Re: Item No. 8.4

**Case 22708: Appeal Hearing
Site Plan Approval Application
1325 Lower Water St., Halifax**

Halifax Regional Council

Precinct One: Southern Waterfront and Downtown Halifax Waterfront Requirements

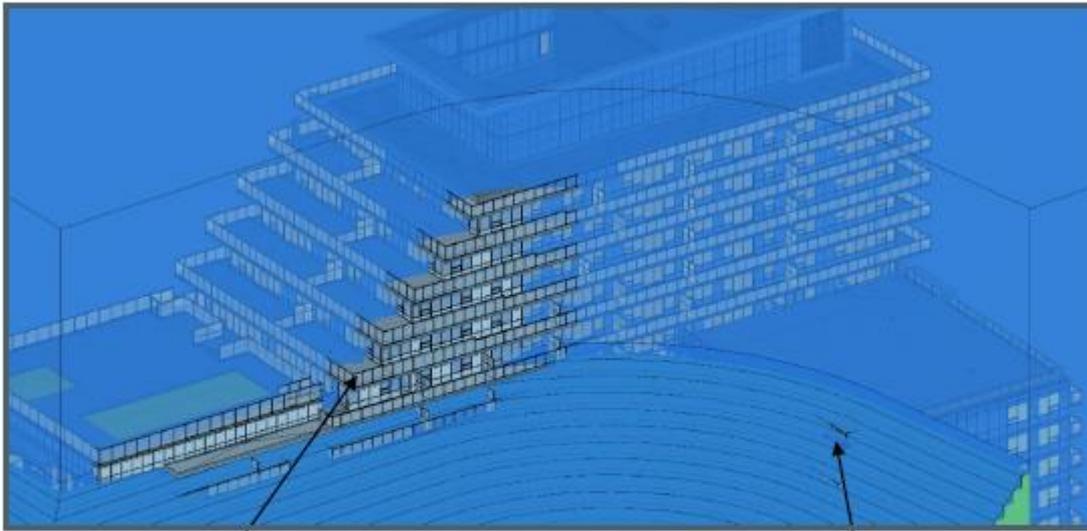
2.10i Ensure building height immediately adjacent to the 8 metre setback shall not be higher than 12.5 metres. Height may increase as distance from the boardwalk or the water's edge increases at a rate of approximately one metre of vertical height for every one metre of horizontal stepback from the boardwalk or water's edge.

Portions of the north-east building face on levels 12, 13, 14, 15 and 16 that are within 30 metres of OHWM and over the required 33.7 metres of building height limit require this variance.

Portion of the railing that is over the required 31.37 metres of building height and within 30 metres of OHWM setback requires this variance.

Variance Category 1 – Side and Rear Yard Setback

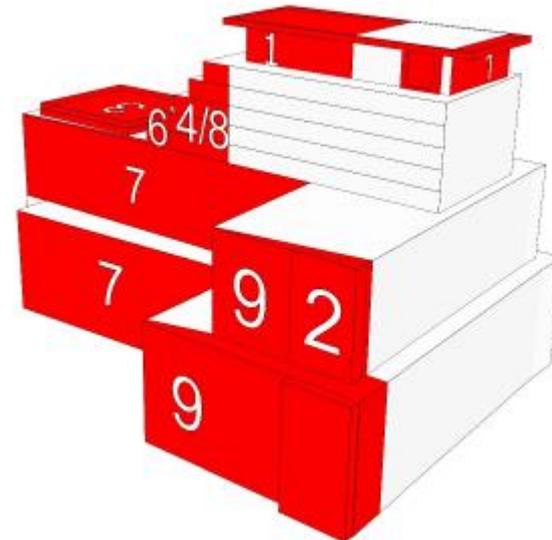
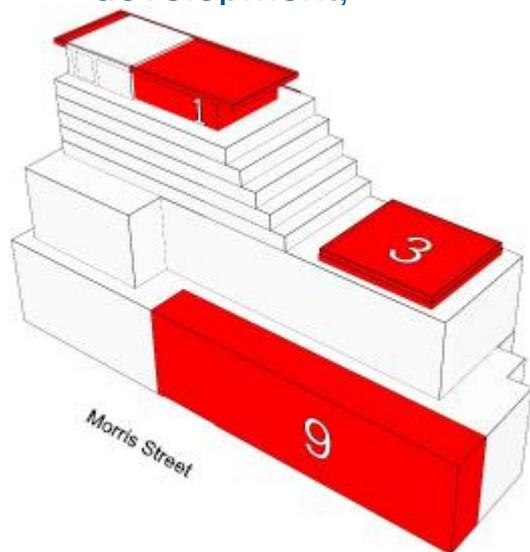
Section 11(1)h of the LUB, which requires that buildings on lots with a streetline width greater than 27.5 m be setback from interior lot lines no less than 10% of the lot width or 8 m, whichever is less (Variance #9)

Staff recommends **approval** based on the following:

- 3.6.2a – the requested variance is consistent with the Design Manual
- 3.6.2b – the variance does not negatively impact abutting uses by providing insufficient separation do not constitute an increase in gross floor area
- 3.6.10a - fill existing gaps created by vacant properties or parking lots with new development;

Variance Category 2 – Upper Storey Side Yard Stepback Variance

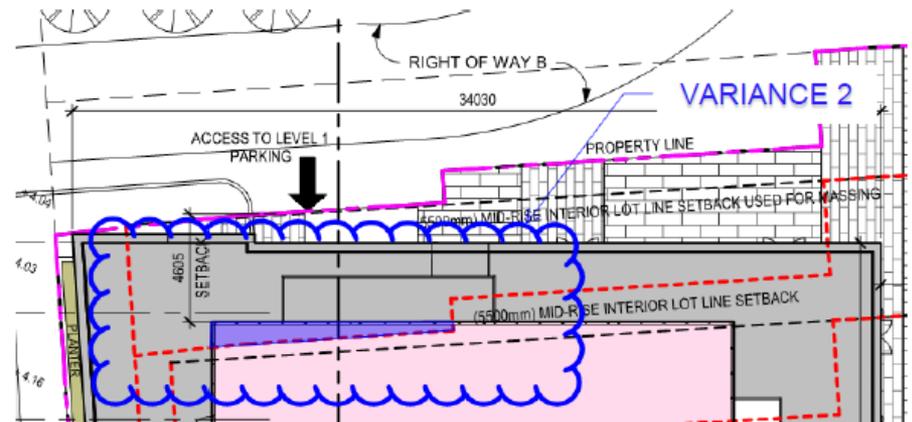
Section 10(4) of the LUB (Variance #2) requires that any portion of a mid-rise building above a height of 18.5 m shall be setback 5.5 m from interior lot lines.

- **Staff recommends approval based on the following:**
 - 3.6.6a – the requested variance is consistent with the Design Manual
 - 3.6.6b – where the height of the building is substantially lower than the maximum permitted building height and the setback reduction is proportional to that lower height

Required Setback – 5.5 metres
Provided Setback – 5.5 metres [4.6 metres only at the N-W corner]

Variance Category 3 – Maximum Height

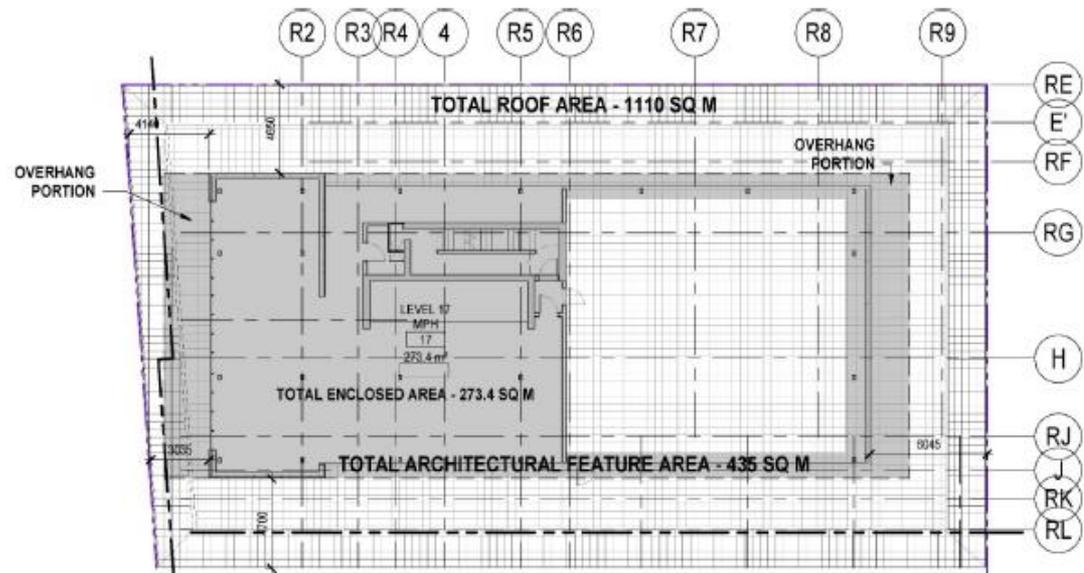
Section 8(8) of the LUB (Variance #1) requires that a mechanical penthouse shall not occupy more than 30% of the roof area.

- Staff recommends approval based on the following:

- 3.6.8a – the requested variance is consistent with the Design Manual
- 3.6.8b – the mechanical penthouse and railings do not constitute an increase in gross floor area

Variance Category 2 – Upper Storey Side Yard Stepback Variance

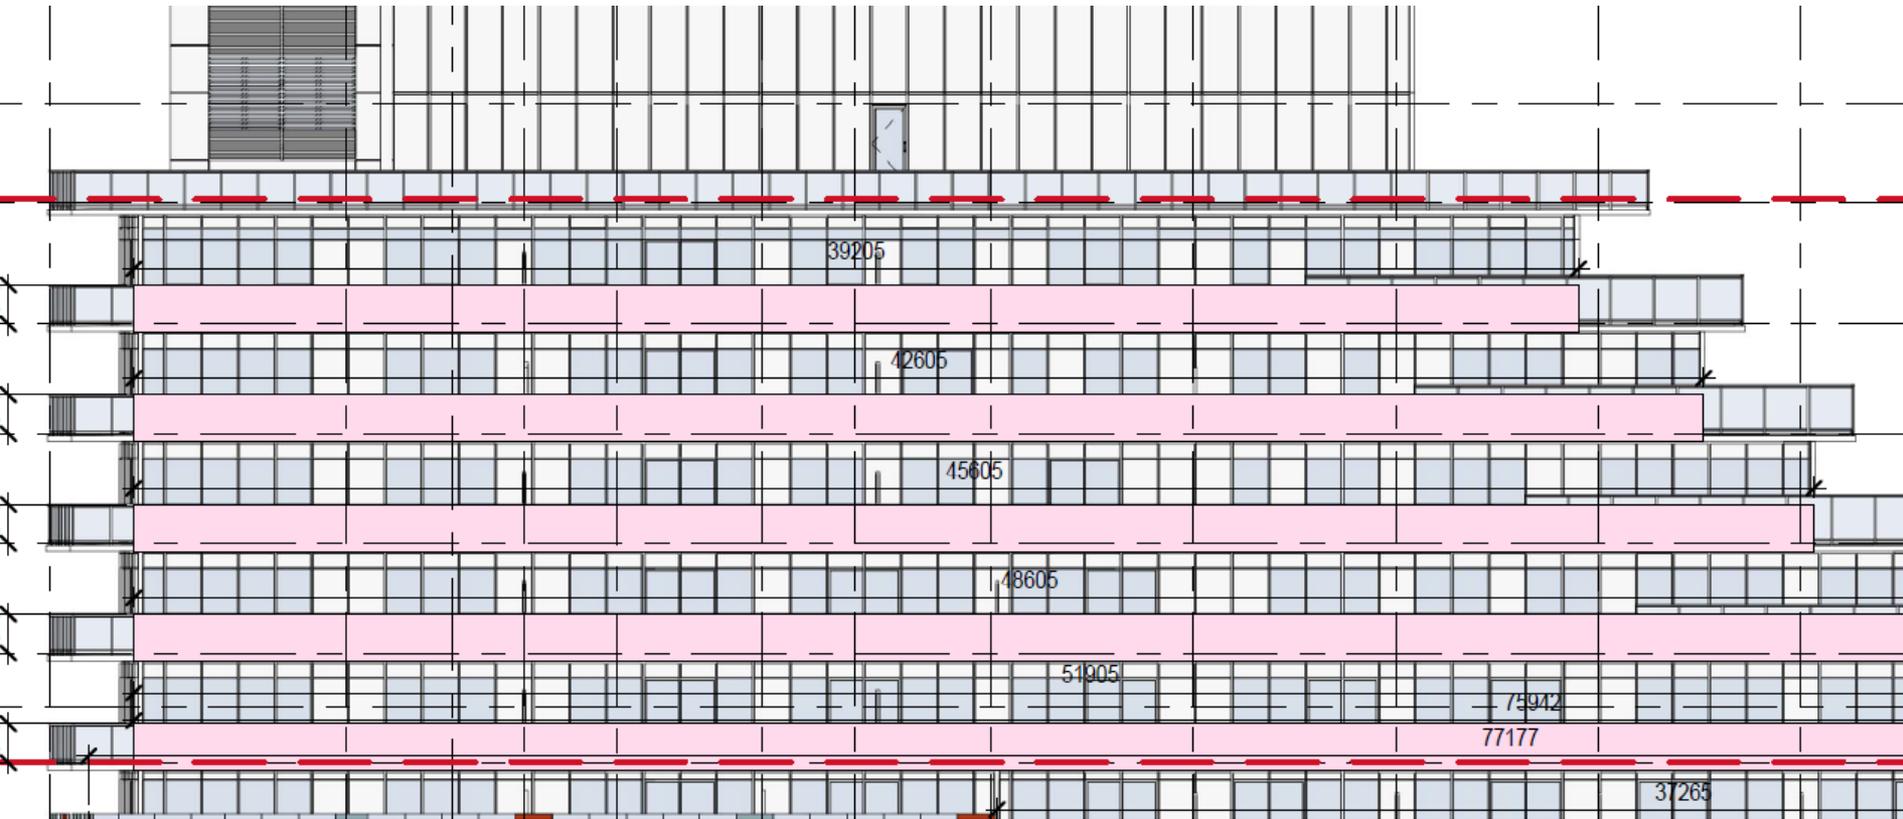
Section 10(13) (Variance #5) which allows balconies to be permitted encroachments into a setback or stepback provided that aggregate length of balconies does not exceed 50% of building face.

LEVEL 12 TO LEVEL 16 - SOUTH BUILDING FACE:
THE AGGREGATE LENGTH OF BALCONY IS 100%
OF THE HORIZONTAL WIDTH OF THE SOUTH
BUILDING FACE

LEVEL 11 - SOUTH BUILDING FACE:
THE AGGREGATE LENGTH OF BALCONY IS 91.25%
OF THE HORIZONTAL WIDTH OF THE SOUTH
BUILDING FACE

LEVEL 8 TO LEVEL 10 - SOUTH BUILDING FACE:
THE AGGREGATE LENGTH OF BALCONY IS 88.12%
OF THE HORIZONTAL WIDTH OF THE SOUTH
BUILDING FACE

LEVEL 6 TO LEVEL 16 - SOUTH BUILDING FACE TOTAL:
THE TOTAL AGGREGATE LENGTH OF BALCONIES IS 86.29%
OF THE HORIZONTAL WIDTH OF THE SOUTH
BUILDING FACE TOTAL

Variance Category 2 – Upper Storey Side Yard Stepback Variance

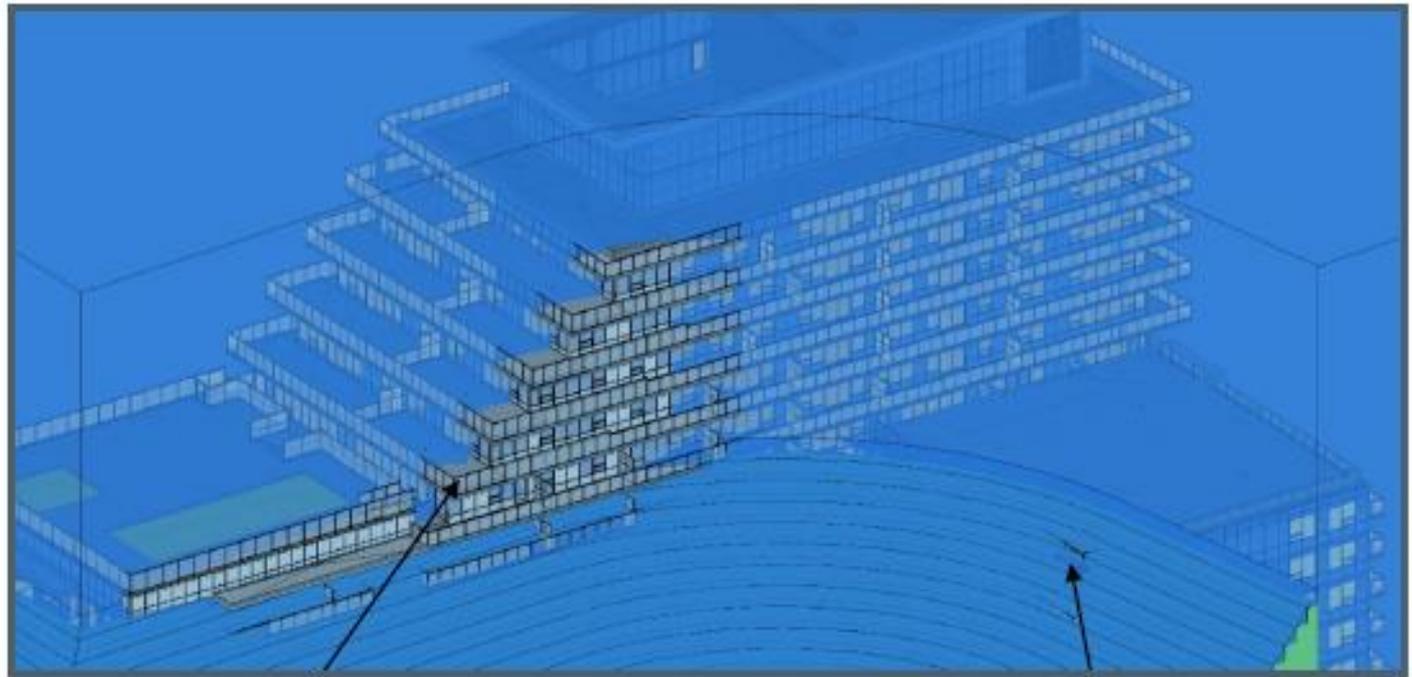
Section 10(13) (Variance #5) which allows balconies to be permitted encroachments into a setback or stepback provided that aggregate length of balconies does not exceed 50% of building face.

Staff recommends refusal based on the following:

- 3.6.6a – the requested variance is inconsistent with the Design Manual and it does not meet either of the criteria below
- 3.6.6b – where the height of the building is substantially lower than the maximum permitted building height and the setback reduction is proportional to that lower height; or
- 3.6.6c- a reduction in setback results in the concealment of an existing blank wall with a new, well designed structure.

DRC did not allow this variance

Variance Category 4 – Precinct 1 Built Form

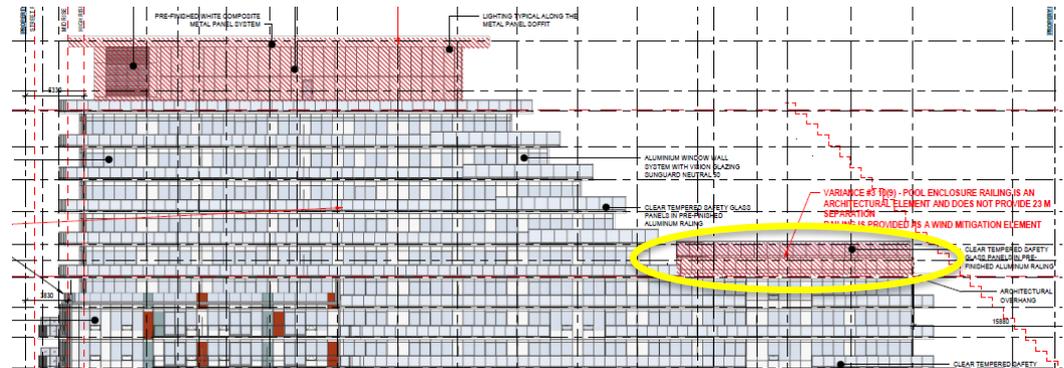
Section 10(10) (Variance #4) states that buildings shall be a maximum width of 38 m and a maximum depth of 38 m, and Section 11(1)f (Variance #8) requires that the maximum width of any portion of a building above a height of 33.5 m shall be 21.5 m parallel to Lower Water Street and a maximum depth of 38.5 m.

While it meets 3.6.10a, **Staff recommends refusal based on the following:**

- 3.6.7a – the requested variance is inconsistent with the Design Manual; and it does not meet the following
- 3.6.7b – the modification results in a clear public benefit such as the remediation of an existing blank building wall;
- **DRC approved this as a clear public benefit**
